MEMORANDUM

SUBJECT: Terrace in Oak Hill (Formerly called West 71 Office Park)
Planned Unit Development Ordinance Number 20070726-104

Proposed PUD Revision

CASE: C814-2007-0009.01
Terrace at Oak Hill
(formerly West 71 Office Park)

EXHIBIT C-1

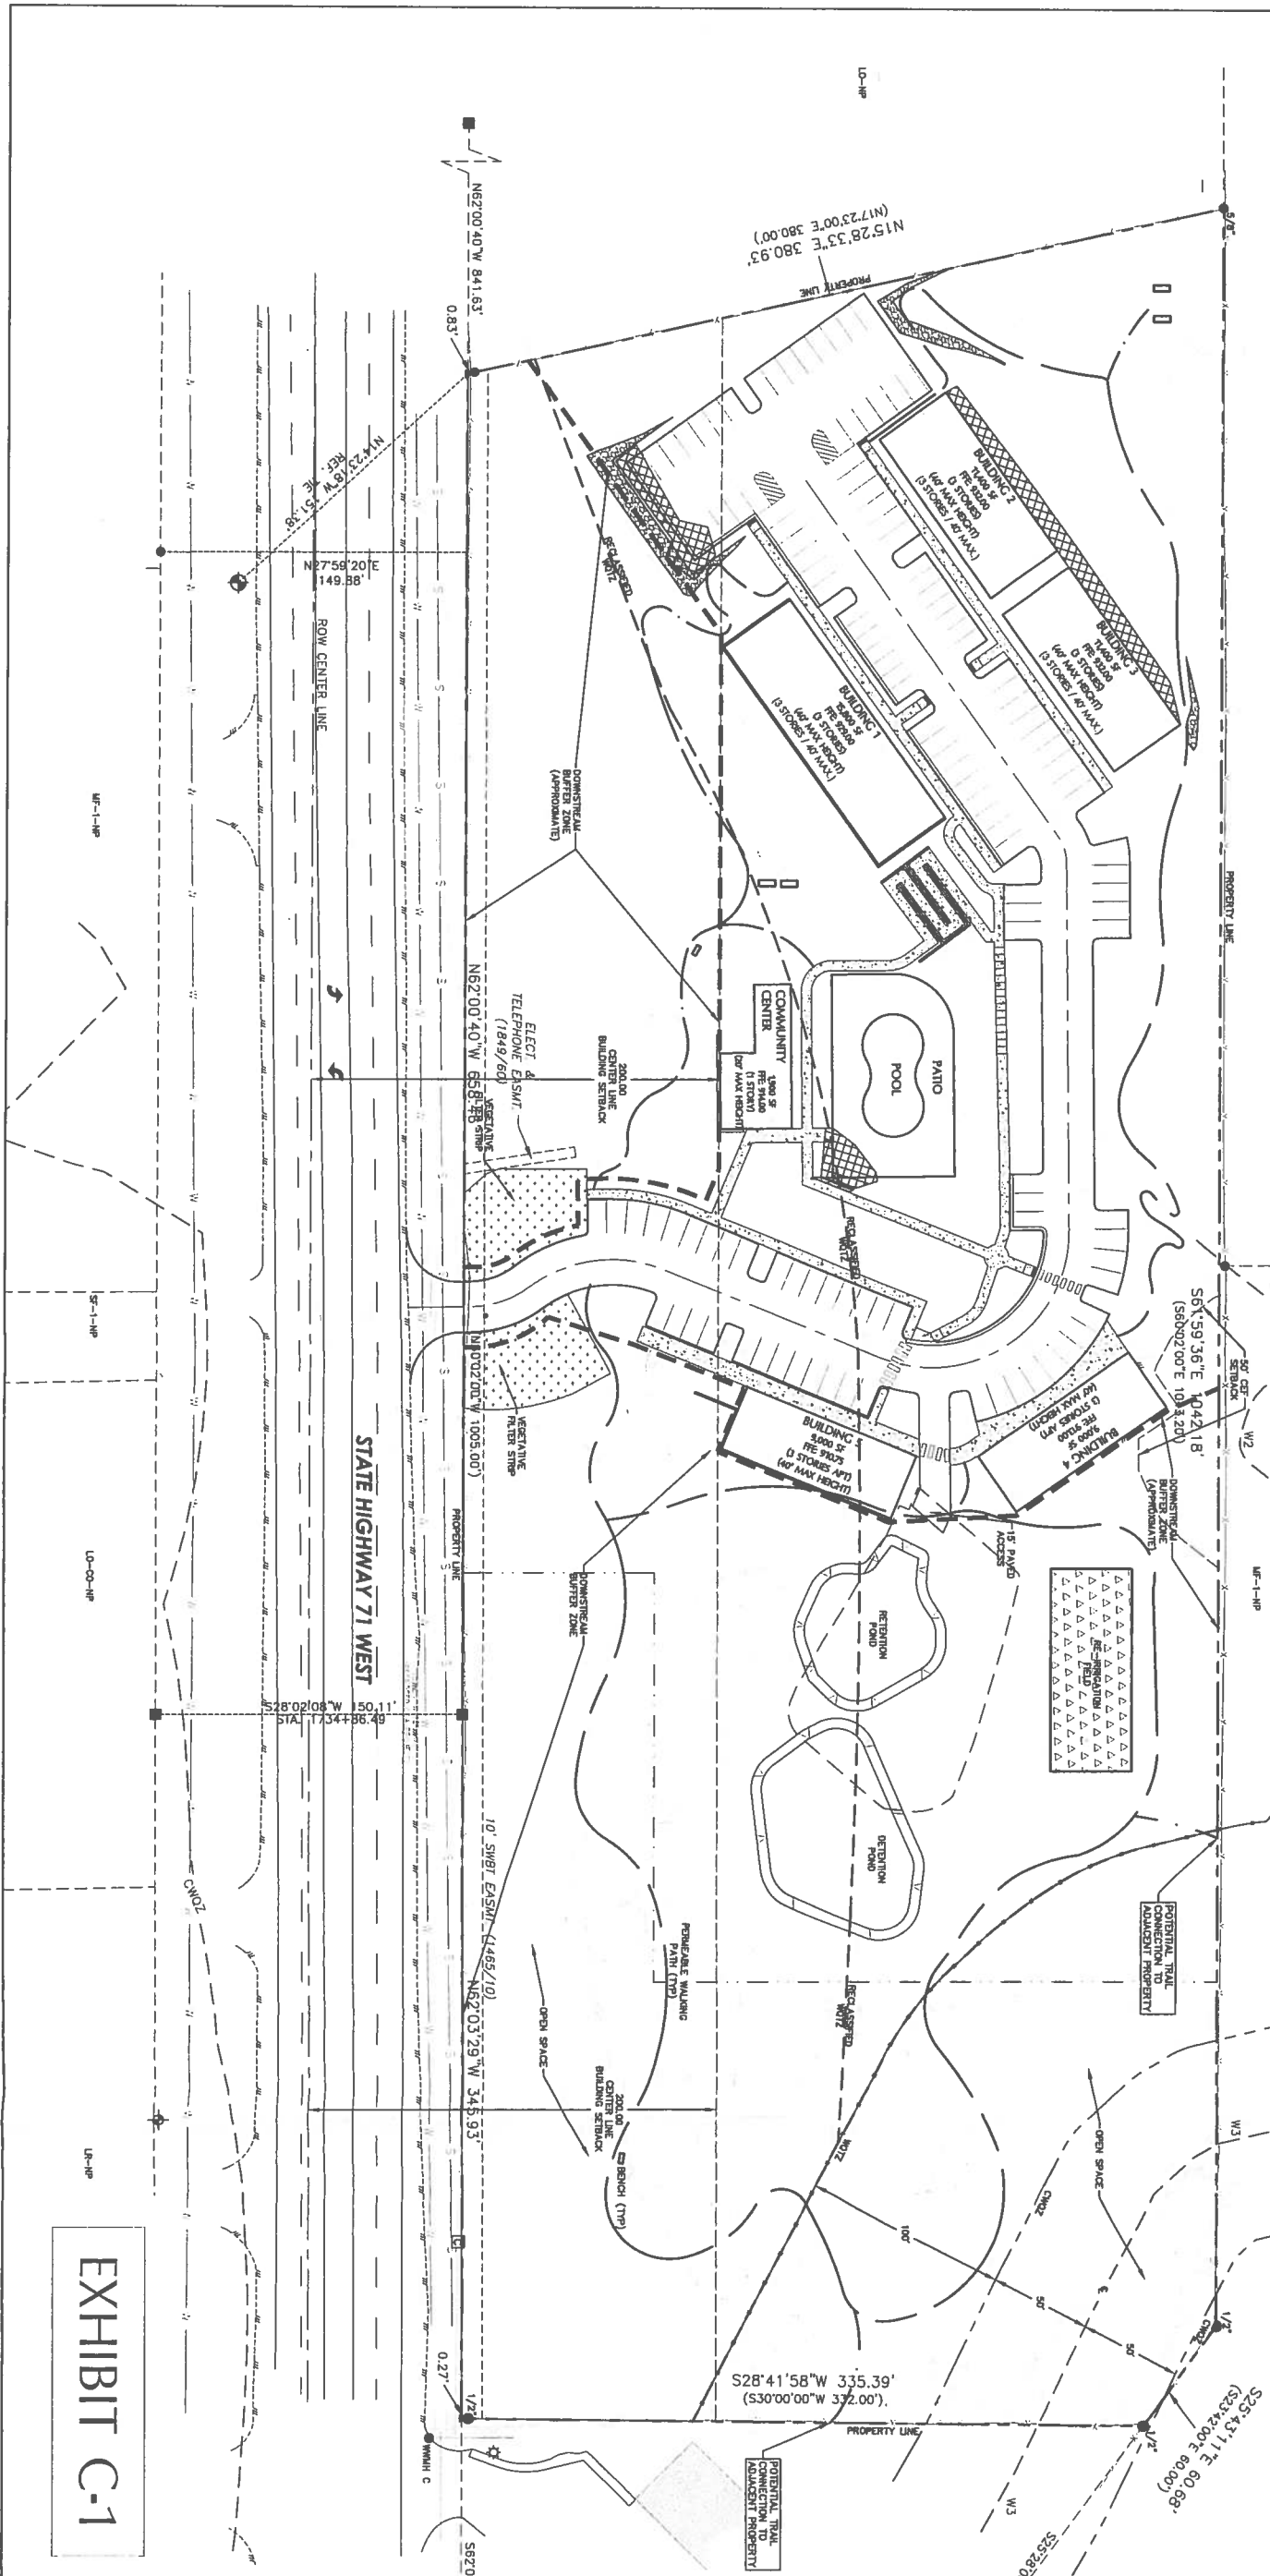
Therefore, the applicant proposes to revise the Critical Water Quality Zone and Water Quality Transition Zone of the unnamed waterway located at the northeast corner of the property (Exhibit D-2 WQTZ Reclassified and Exhibit D-3 CWQZ Reclassified) to reflect current GIS data. This revision will not alter the language of the approved PUD Ordinance; but will require a revision of Land Use Plan associated with the PUD Ordinance (Exhibit C-1 Proposed Land Use Plan and Exhibit C-2 Proposed Land Use Notes).

Therefore, the Land Use Plan must generally show the areas of cut / fill from 4 to 8 feet as identified in Exhibit D-4 Cut and Fill. In addition, for clarity, at the time of site plan submittal and subsequent site plan review by Staff, Staff recommends that items 2.a. through 2.d. (above) be documented in the revised PUD Ordinance or Land Use Plan.

EXHIBIT D-1

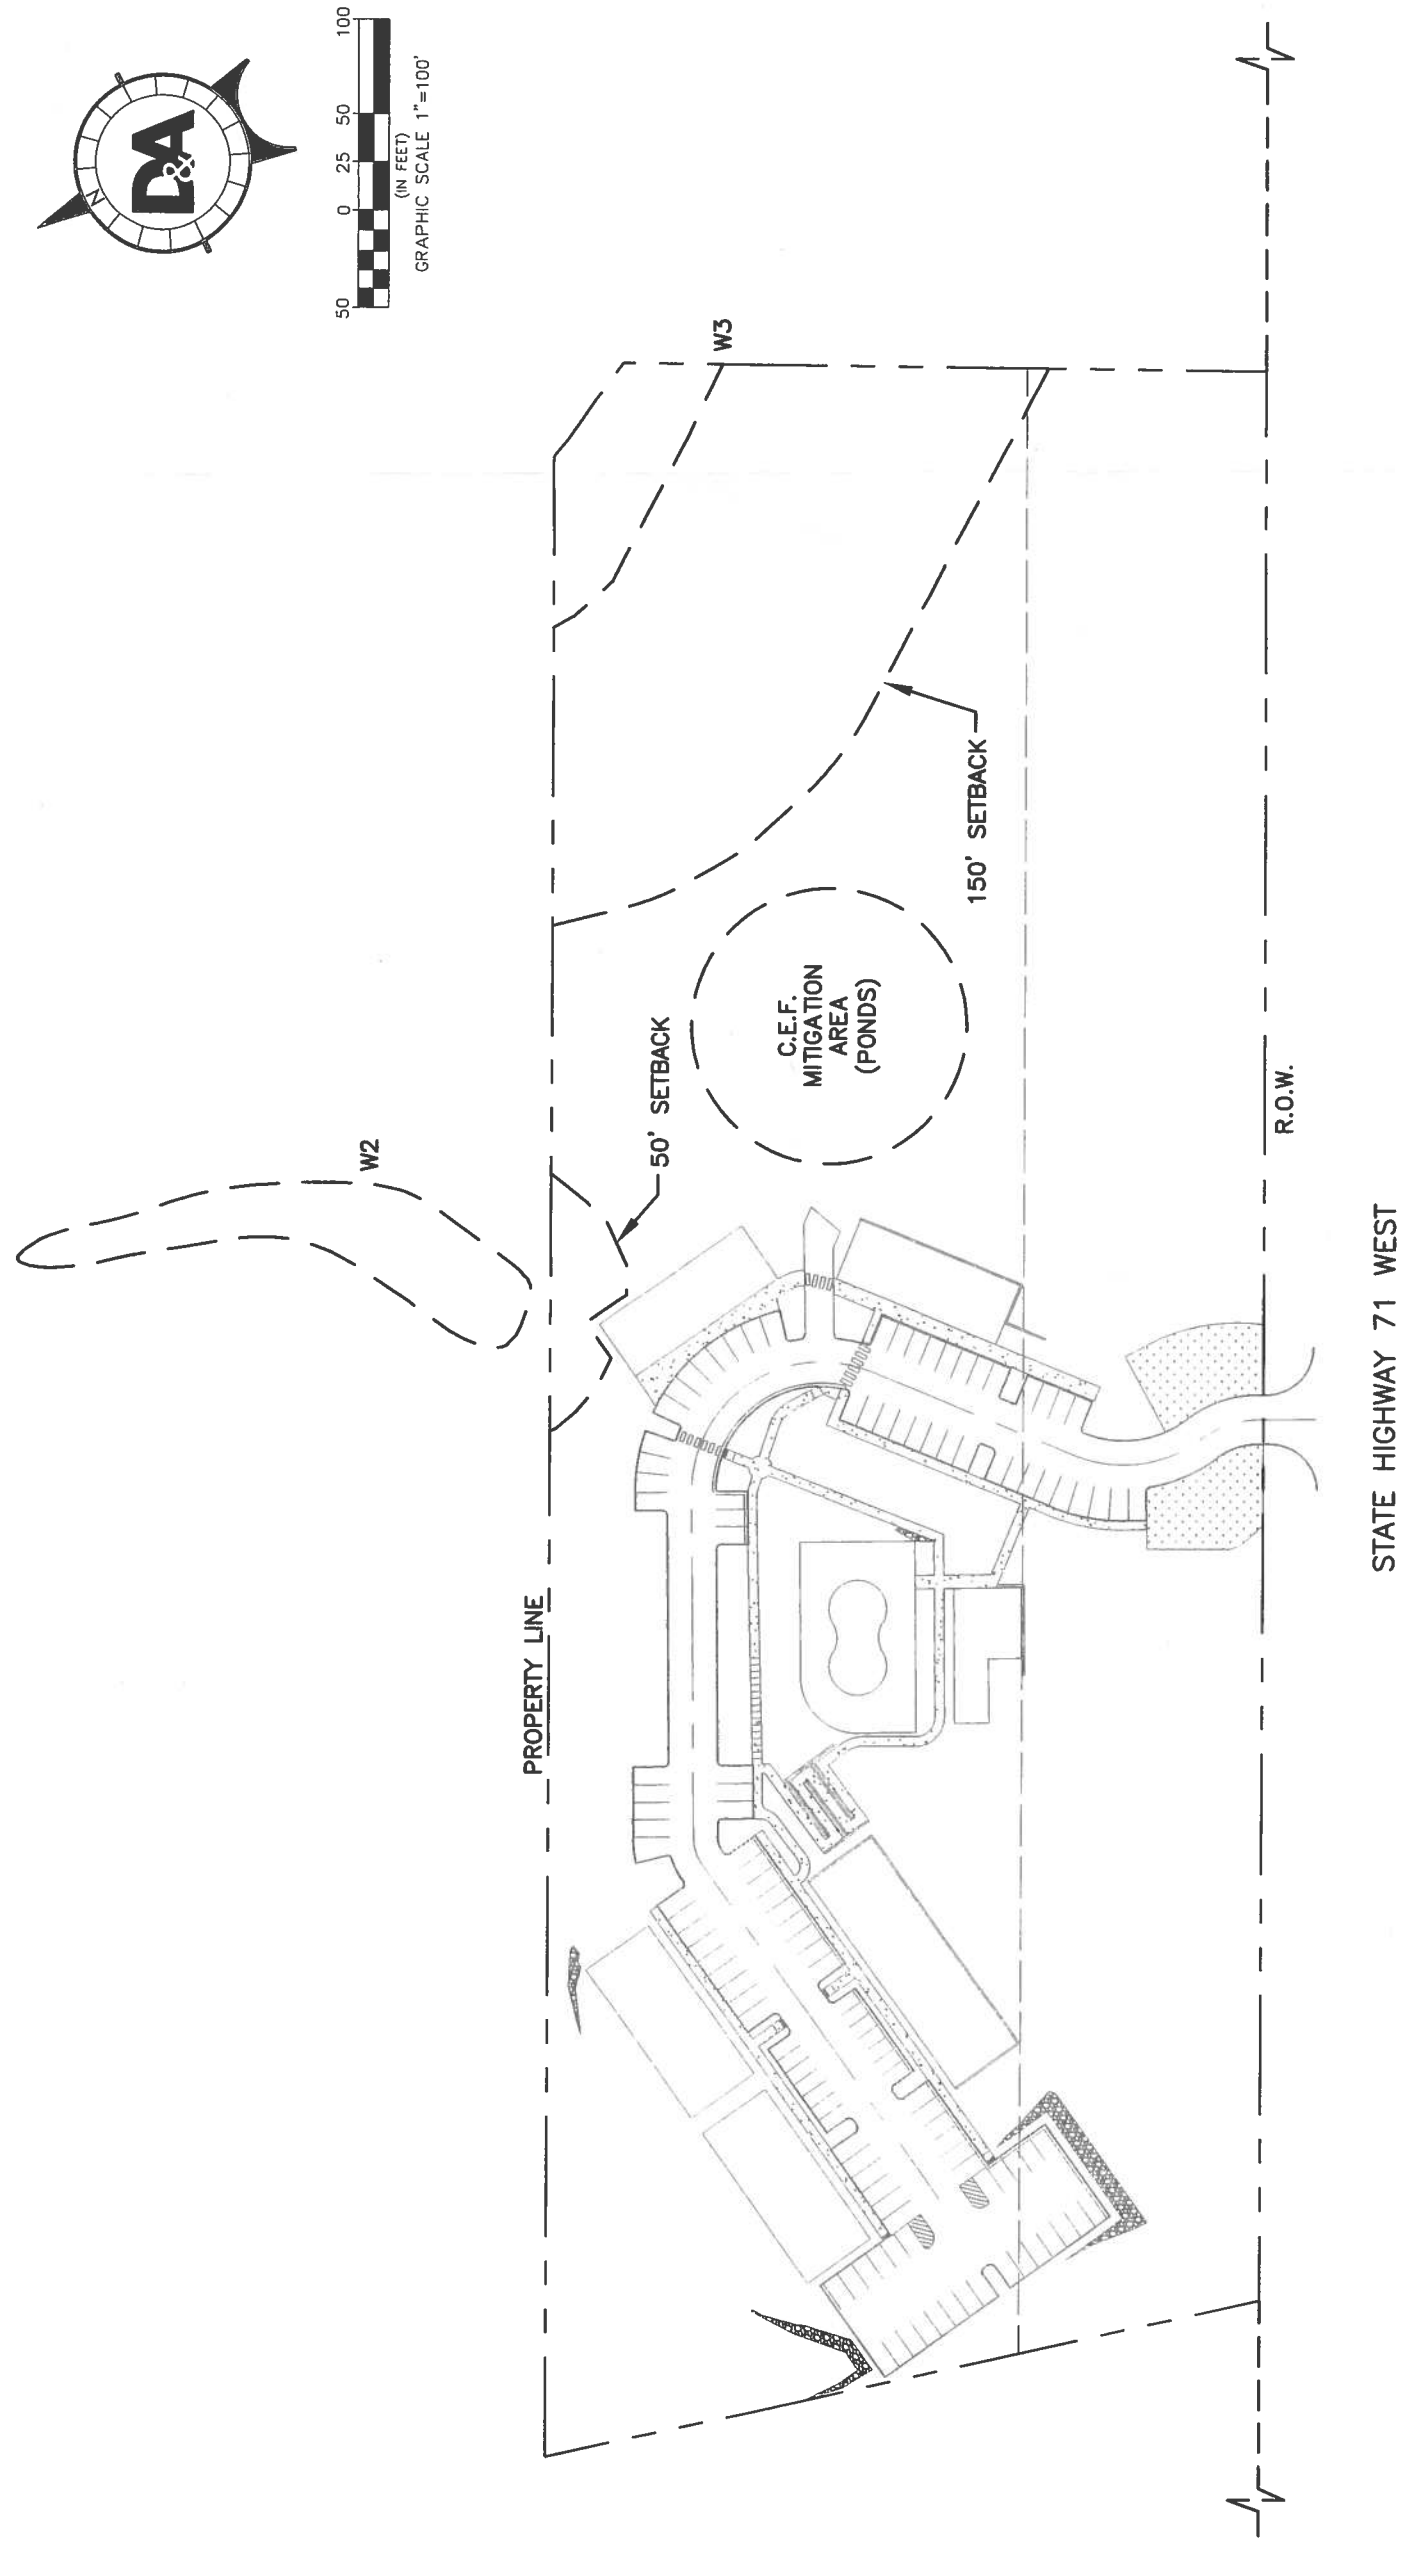
Two wetland Critical Environmental Features (W2 and W3) have been identified (Exhibit D-1 Critical Environmental Features). Wetland Critical Environmental Feature W2 is located offsite, wetland Critical Environmental Feature is located on the property.

The proposed development encroaches into a 50 foot wetland Critical Environmental Feature setback (Exhibit D-1 Critical Environmental Features). Wetland mitigation on site will account for this encroachment; the Critical Environmental Feature setback boundary will be notched to coincide with the building footprint encroachment.

- 6. The Land Use Plan will show on site wetland mitigation to account for the building / Limit of Construction encroachment into the 50 foot setback for wetland Critical Environmental Feature 'W2'. The setback boundary for wetland Critical Environmental Feature 'W2' will be adjusted to coincide with the building footprint / Limit of Construction.

EXHIBIT D-2

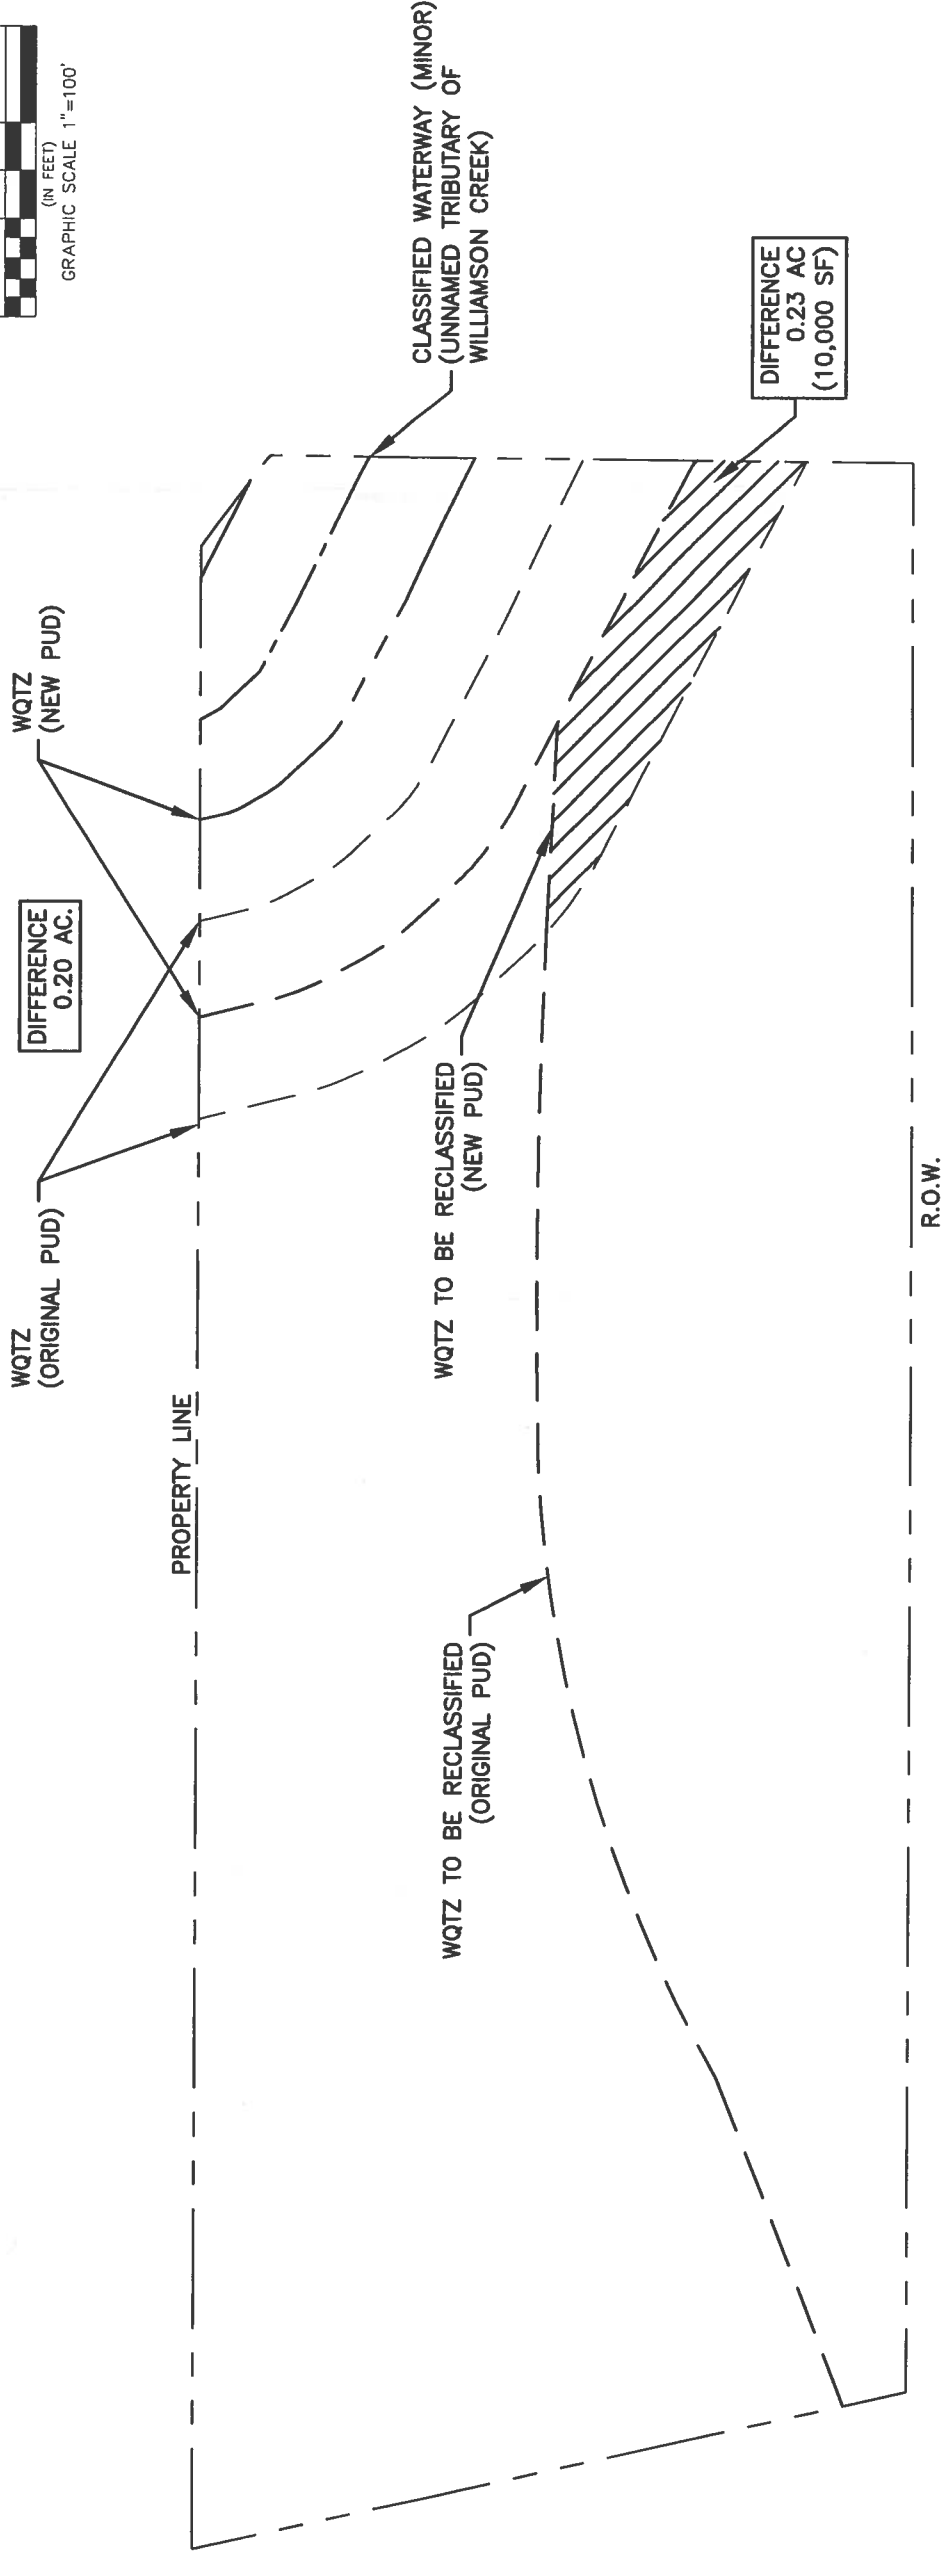
3. The hatched area shown on Exhibit D-2 WQTZ Reclassified represents an overlap between the east-west trending Water Quality Transition Zone and the northeast corner Water Quality Transition Zone as it appears on the current approved PUD Ordinance (i.e., the hatched area represents the Water Quality Transition Zone of two different waterways). With the proposed realignment of the northeast corner Water Quality Transition Zone, the hatched area will be located **exclusively** within the east-west trending Water Quality Transition Zone. This is pertinent in that Part 4.B of the currently approved PUD Ordinance states that the east-west trending Water Quality Transition Zone is defined as Uplands Zone. With the realignment of the northeast trending Water Quality Transition, the 0.23 acre hatched area will be designated as Uplands for the purposes of calculating allowable impervious cover on the property. The result will be an additional 2,505 square feet of allowable impervious cover on the property. However, this specific 0.23 acre area is not buildable due to the proposed downstream buffer (described below).
